Engineering - Final Plat Checklist

14-155 Fairpark Cottages 2 PLAT 2-5-18.pdf

Project 6628 Fair Park Cottages Revision 2.pdf

9. 0. General Information

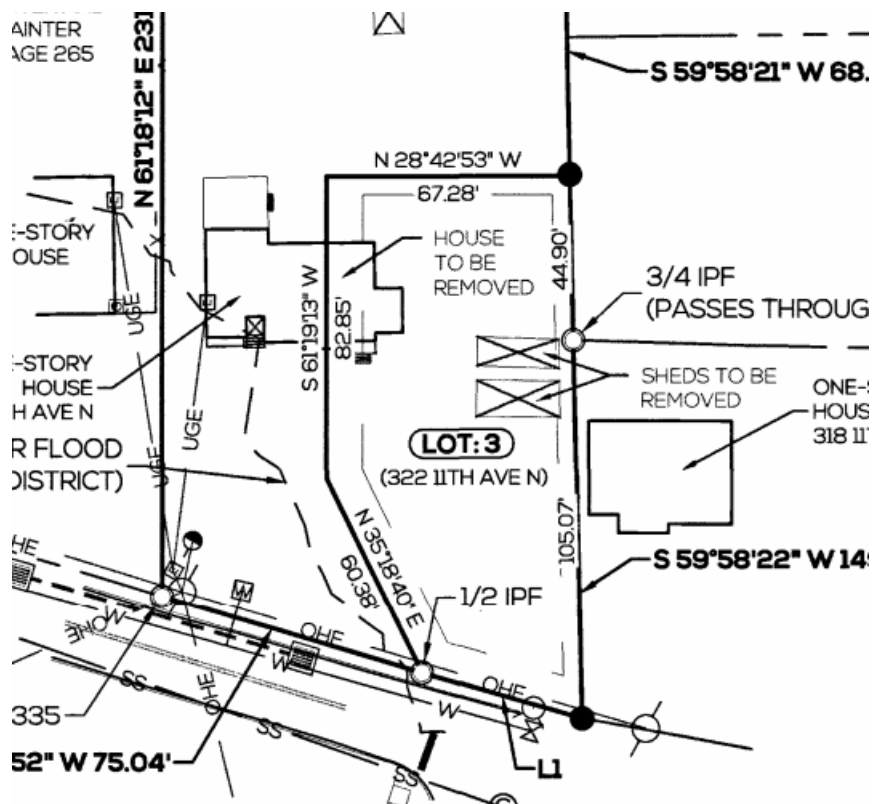
lance.fittro@franklin.tn.gov The lot currently labeled as Lot 3 on the submitted plat shall be renumbered:

Lot 3 was already assigned to the lot located at 322 11th Ave. N when it was recorded with Plat Book P63 Page 87:

11. C. Final Plat

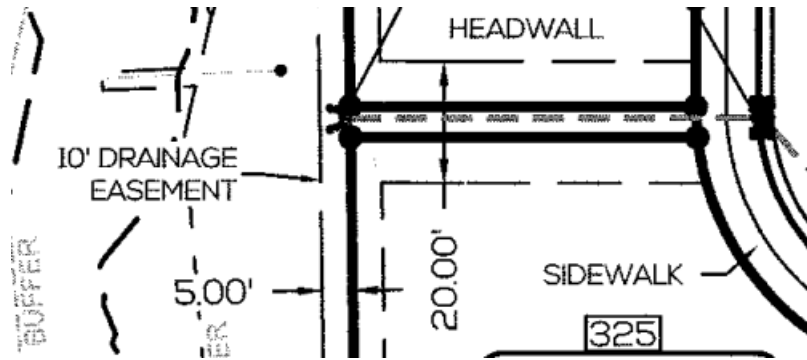
lance.fittro@franklinton.gov Applicant shall add "Drainage Easement" to the 20' dimension label for the easement shown below so that it is clear this is an easement and not just a building setback line.

20. Stream Buffer

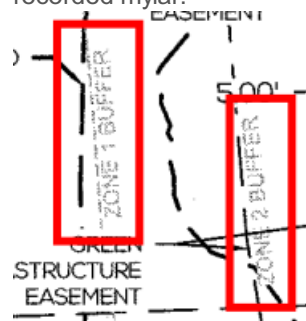
Applicant to revise the stream buffer information now shown on the final plat (pages 2 and 3) as follows:

1. Provide all "black" line work and text on the plat to facilitate reproduction from the recorded mylar.

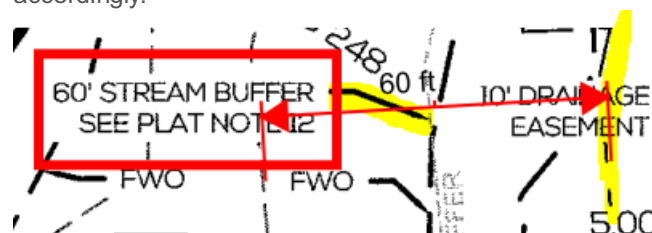
2. "60' stream buffer" note is pointing to an incorrect line. Applicant to revise leader accordingly.
